AMENDMENTS TO THE DRAWINGS

REMARKS/ARGUMENTS

Figure 1

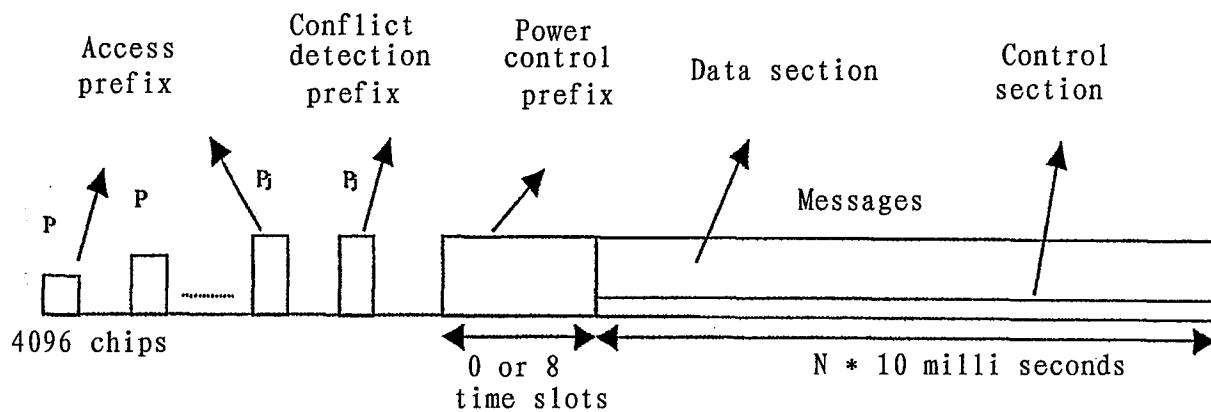
The attached sheet of drawings includes changes to Figure 1. This sheet, which includes Figures 1-2, replaces the original sheet including Figures 1-2. In Figure 1, "PRIOR ART" is labeled.

Figure 1 is objected to because a legend “PRIOR ART” is not designated. Figure 1 is amended to overcome the objection.

Prior Art
